June 10, 1985
VP-85-0132

Subject: Detroit Edison Response
Inspection Report 50-341/85009

RESPONSE TO NRC INSPECTION REPORT NO. 50-341/85009

Unresolved Item 85-009-01

TYPICAL 4160V BUS POTENTIAL DIAGRAM

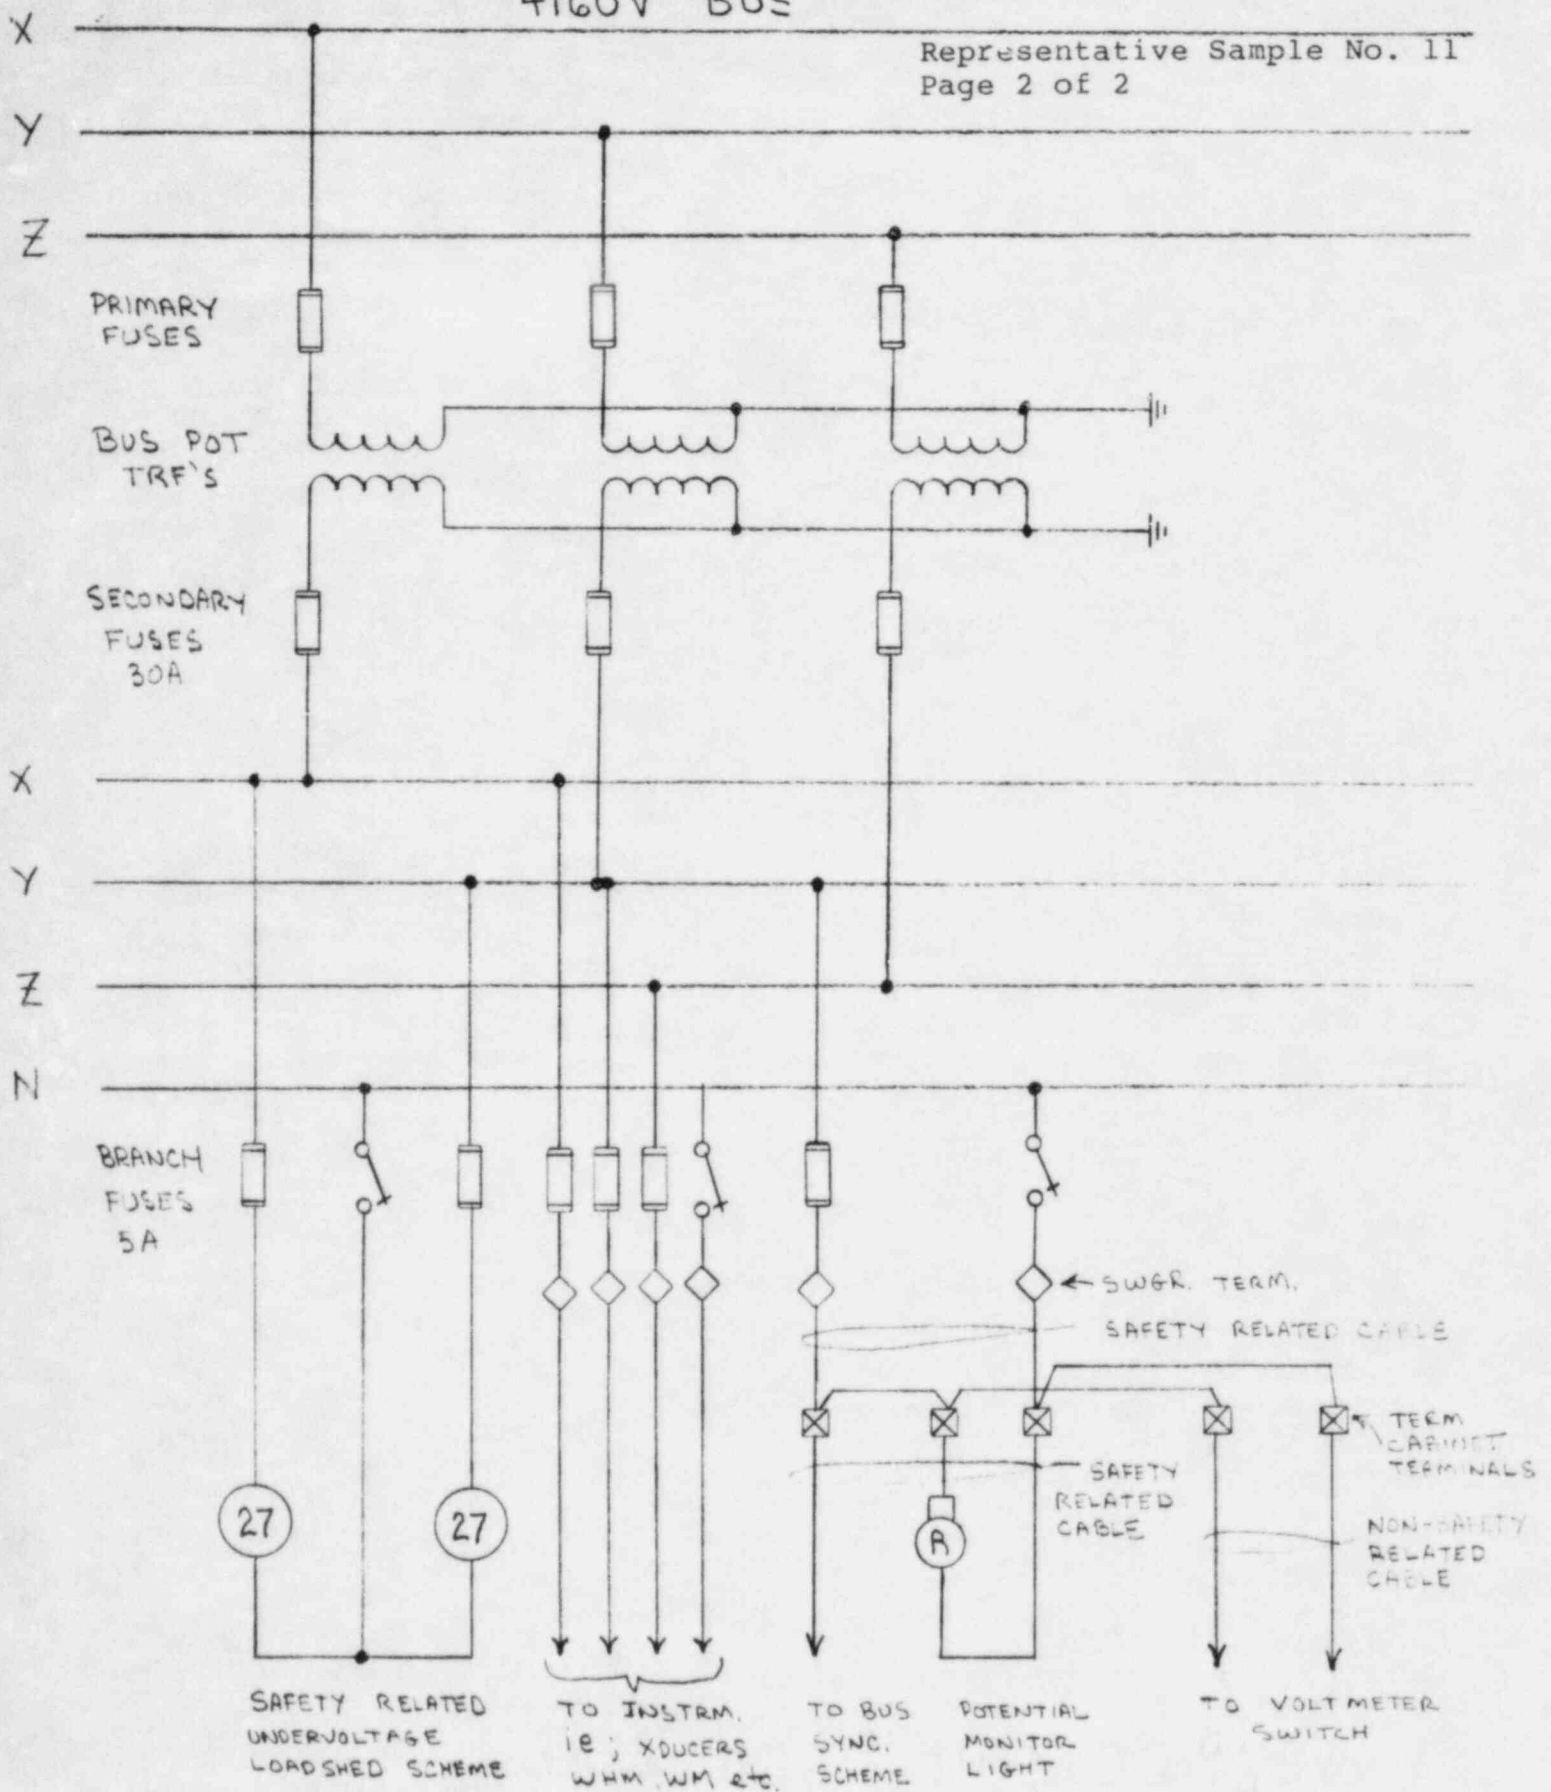
2. FAILURE MODES: (Refer to Attached Sketch)

- a. Short circuit in Non-IE circuits
- b. Open circuit in Non-IE circuits

- a. All branch circuits are individually fused and the ~~fuse~~ sizes are selected to coordinate with the potential transformer secondary fuses.
- b. All circuits being fed from the termination cabinet are functionally Non-IE i.e., indicating and recording instruments or a bus synchronizing scheme which are not needed for safe shutdown of the plant.
- c. The IE bus undervoltage load shed scheme located in switchgear is isolated from other branches by selective fuses. The undervoltage load shed scheme will not be affected by faults on the Non-IE circuits, as the scheme has a built-in two second delay to override transient effects of the faults.
- d. Open circuits in any of the branch circuit cables of the Non-Class IE systems will not affect safe shutdown of the plant.

All branch circuits are electrically isolated and therefore a failure on a Non-Class IE cable will not affect a Class IE system.

Representative Sample No.: 12

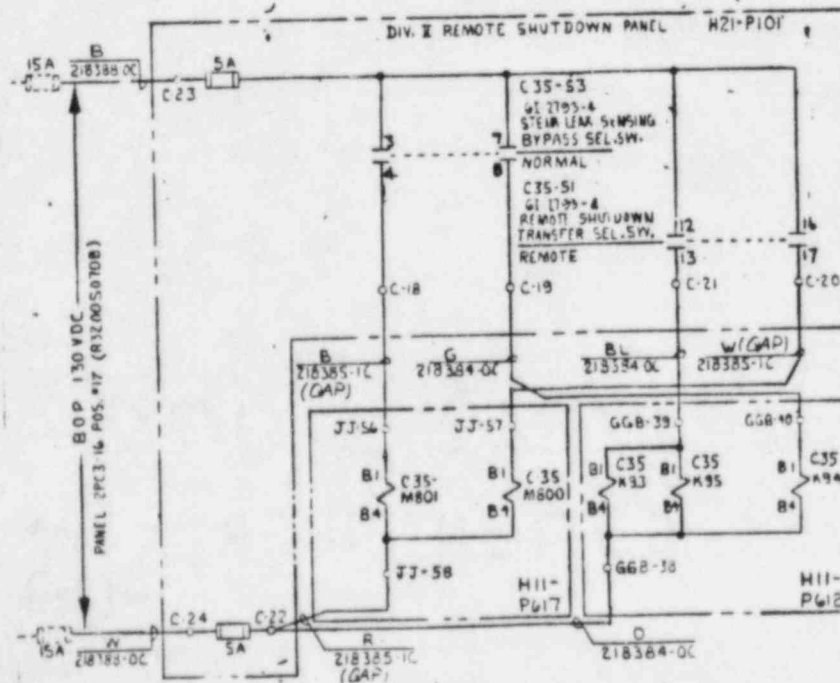
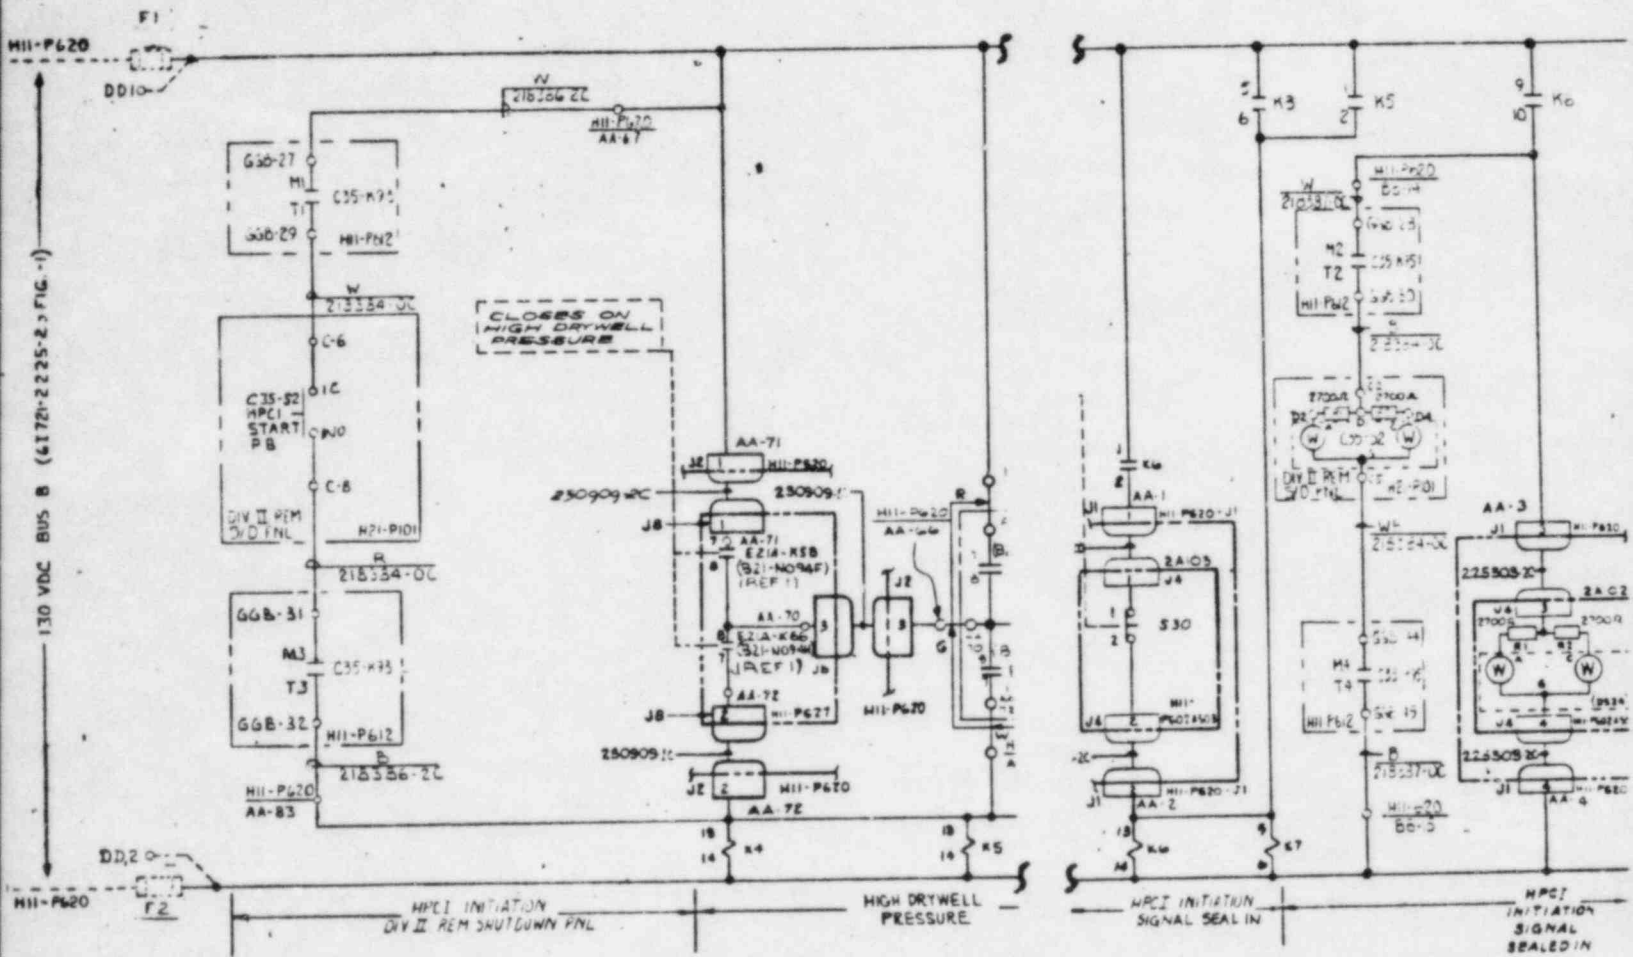
The HPCI initiation from the remote shutdown panel contains BOP cable 218384-04 and Division II cable 218386-2C in same circuit.*

The circuits in question include the "manual initiate" pushbutton which is located in the Non-IE shutdown panel. This pushbutton is isolated through the use of qualified relay contacts M₁-T₁ and M₃-T₃ of relay C35-K73. The isolation relay is normally deenergized and is located in a qualified panel. It is controlled by Non-IE 130V battery power via a key locked transfer switch.

Associated with the pushbutton is the "HPCI INITIATED" lamp located on the Non-IE shutdown panel. The lamp is isolated by a circuit similar to the pushbutton except that contacts M₂-T₂ and M₄-T₄ of a separate relay C35-K35 are used.

A fault may take place in the Non-IE shutdown panel circuits. Since these circuits are normally deenergized, except during the specified fire mitigation, the two open contacts in series constitute adequate isolation of the Non-IE remote shutdown panel from the HPCI logic.

For this specific case the level of isolation provided (relay contacts of a qualified relay in a Class IE equipment panel) is adequate to maintain the integrity of the HPCI system.
